# ADDENDUM No. 1

RFP No. 22-49

## Ellsworth Road Sidewalk Gap Elimination

CITY OF ANN ARBOR - PUBLIC SERVICES - ENGINEERING  
ELLSWORTH RD SIDEWALK GAP ELIMINATION  
PROPOSED STORM SEWER  
CULVERT AND HEADWALL EXTENSIONS  
SCALE PLAN: 1" = 20'  
PROFILE: 1" = 2'  
DRAWING No. 2022007-23

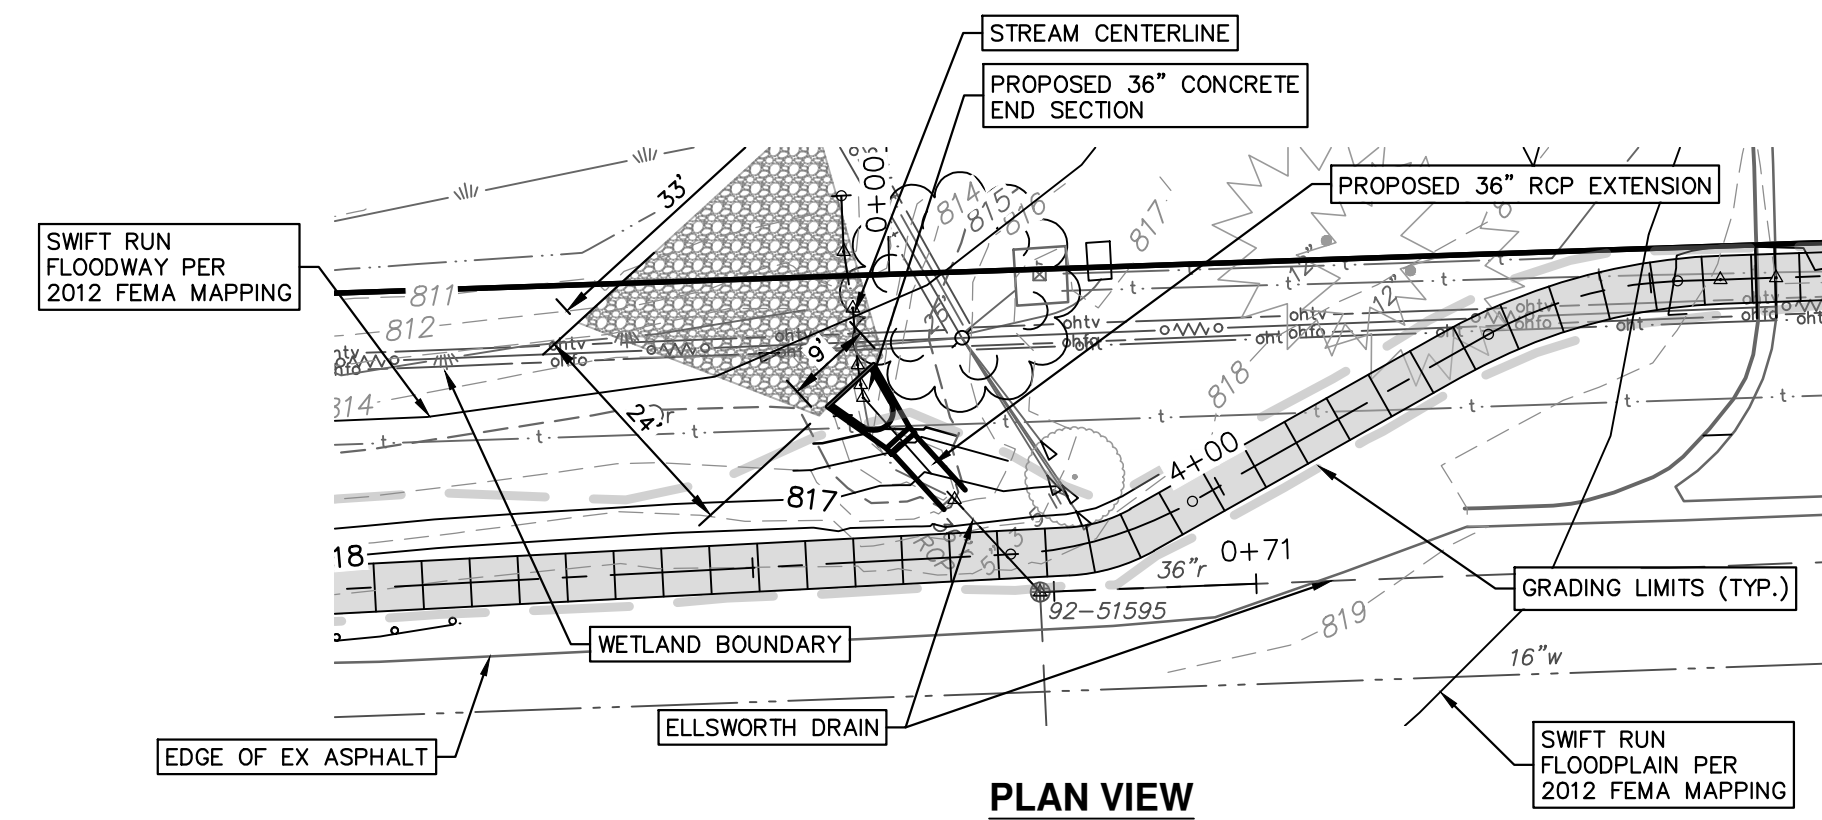
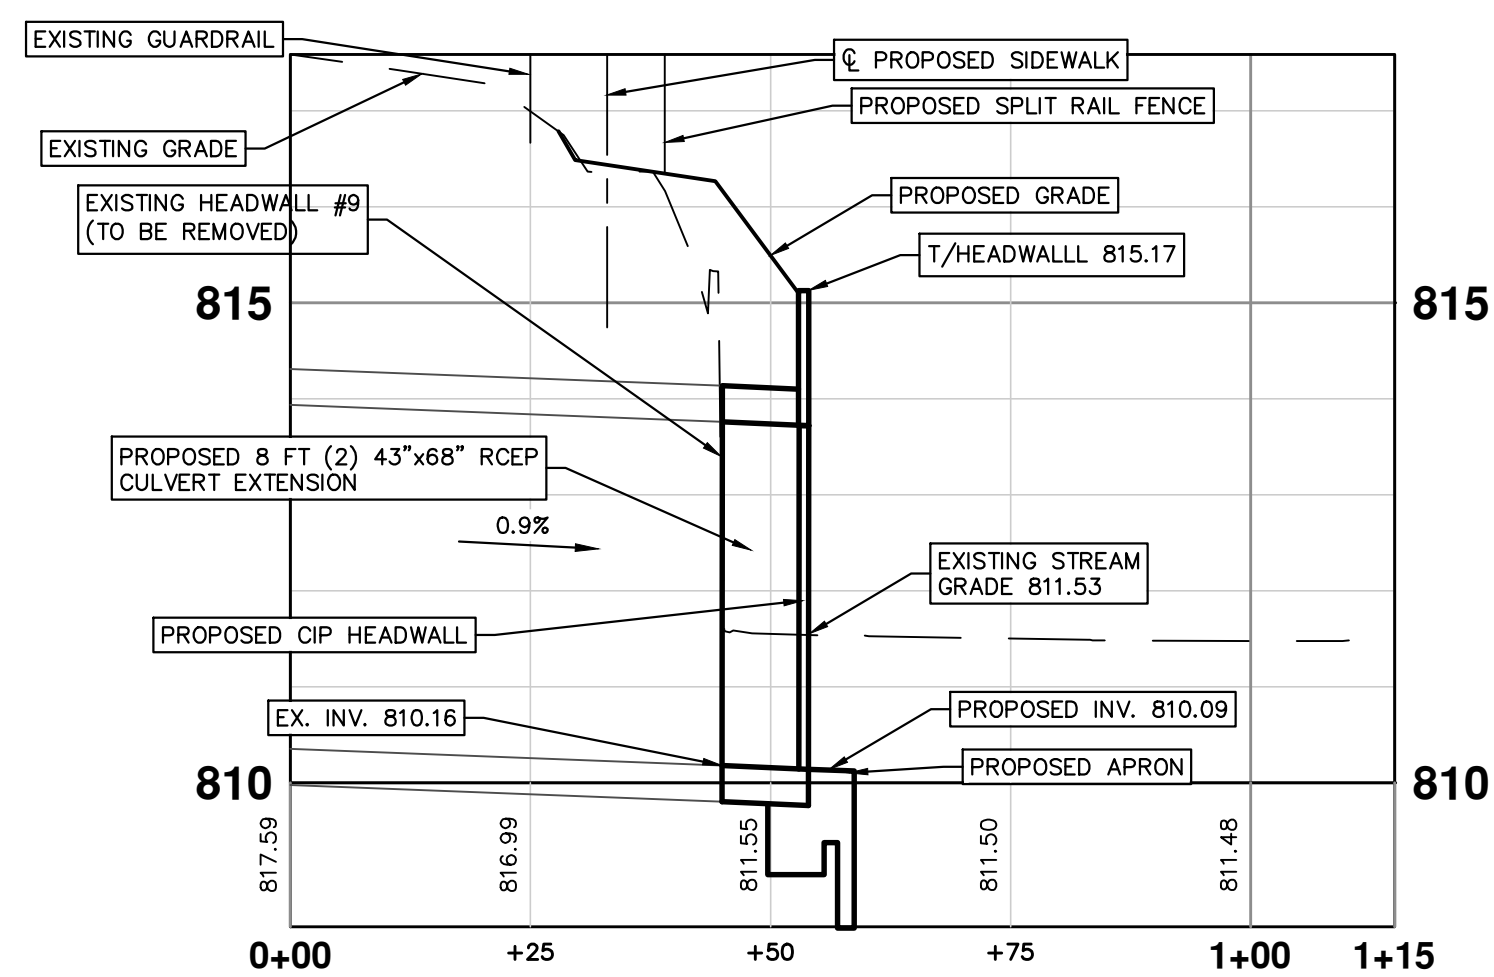
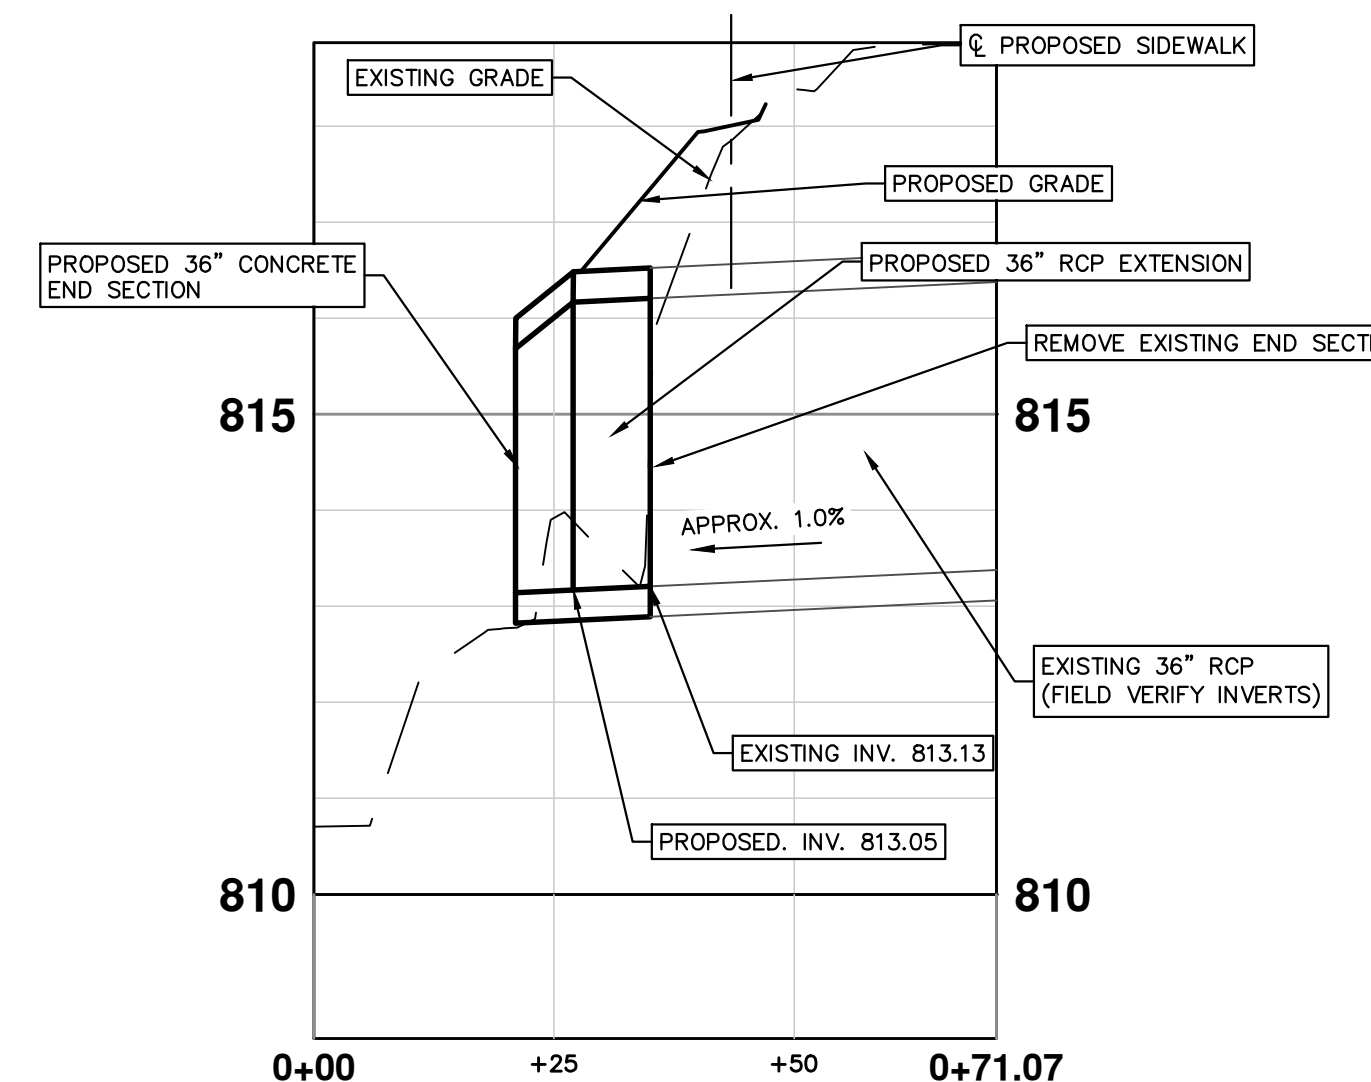
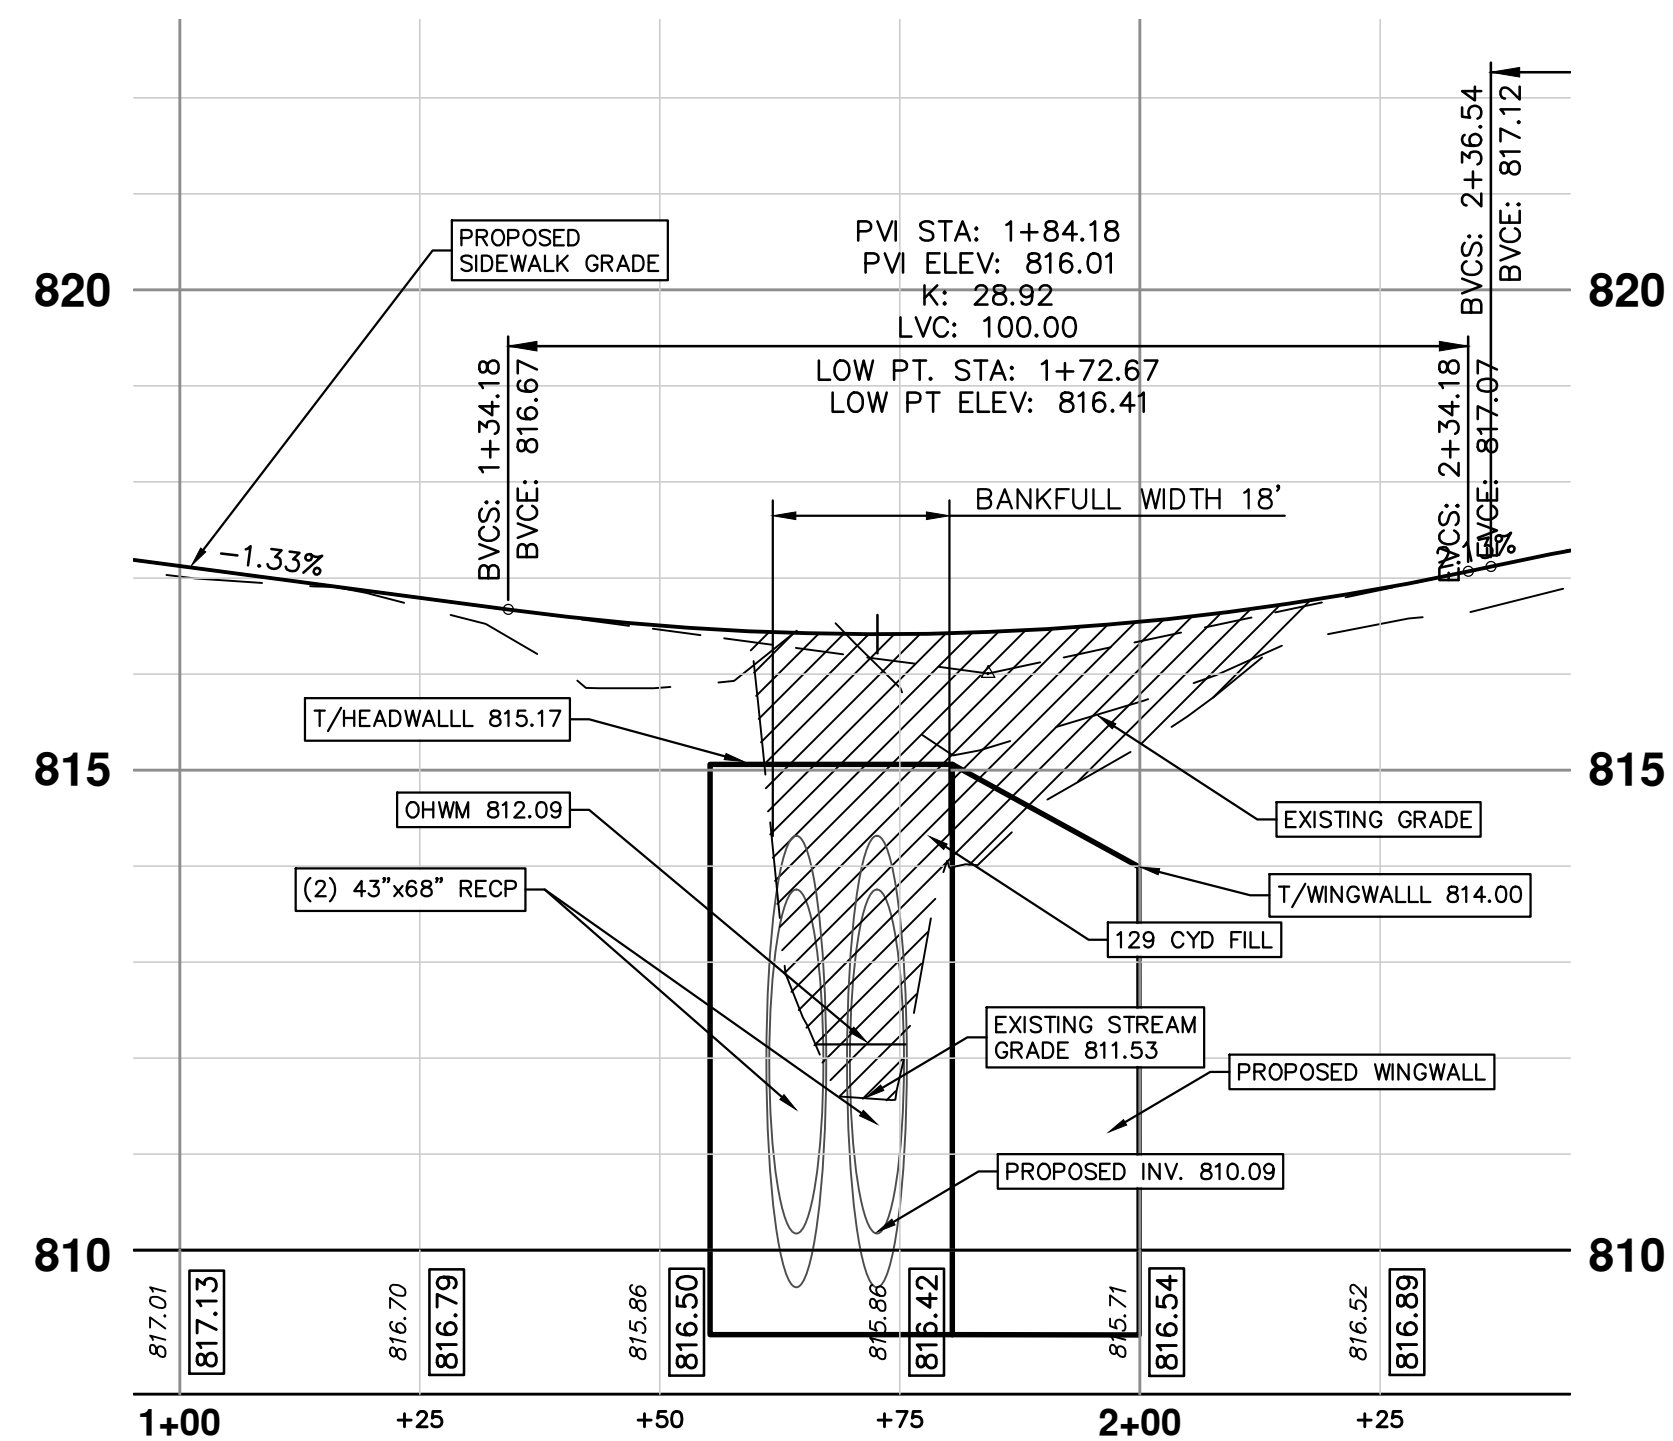
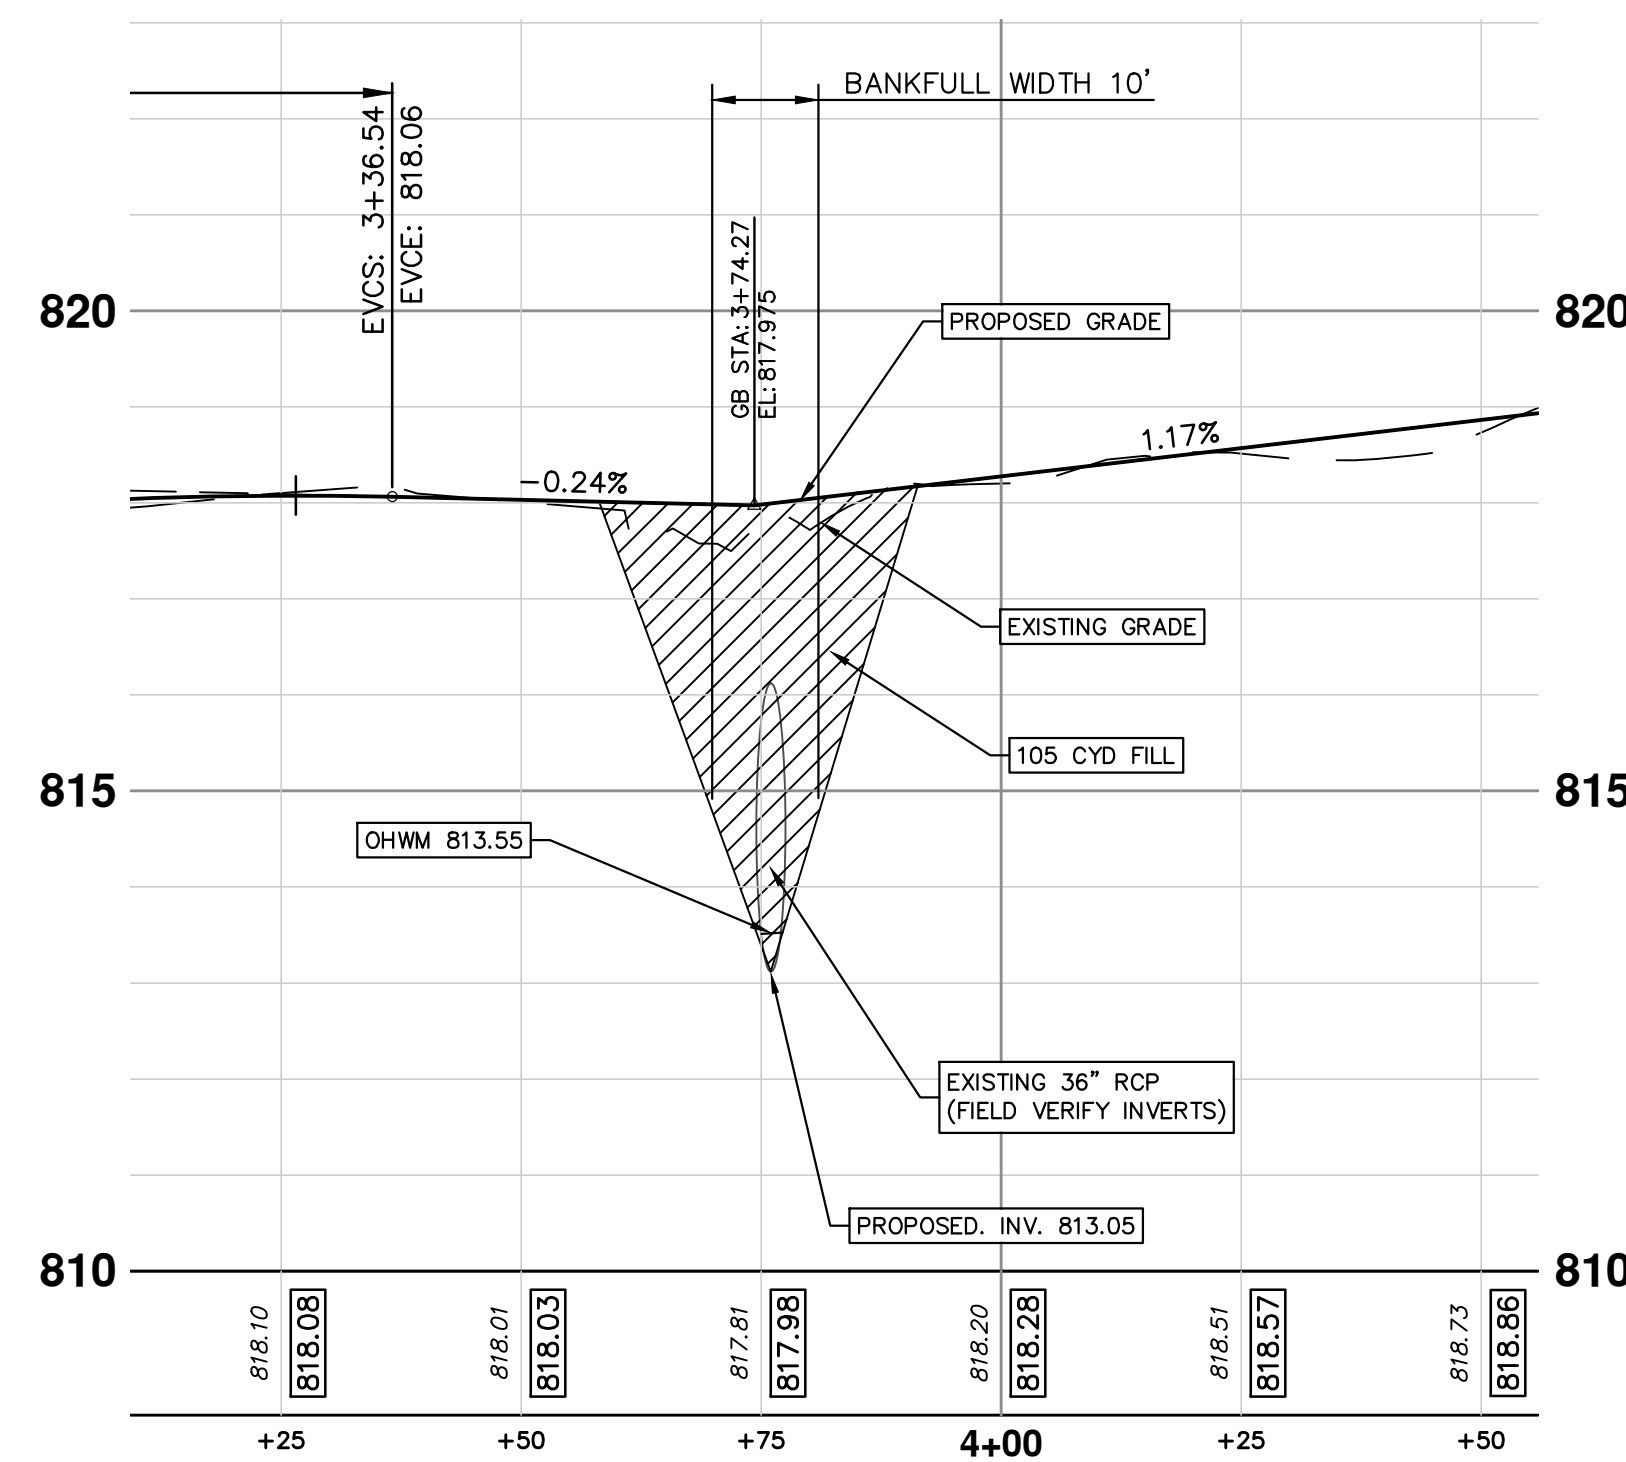
Drawing Plan / 22 and 23 of 24	Added Turbidity Curtain
Drawing Plan / 23 of 24	Added Sheet 23 to Plan Set (Previously provided in Appendix)
Drawing Plans / Multiple	Added Additional Easement Information Added Floodplain/Floodway Information Added Restoration Quantities and Native Seed Quantities Updated Sidewalk Type Quantities
<i>Comment: The intent with this change is to simply replace the plan set with Drawing Plans provided herein.</i>
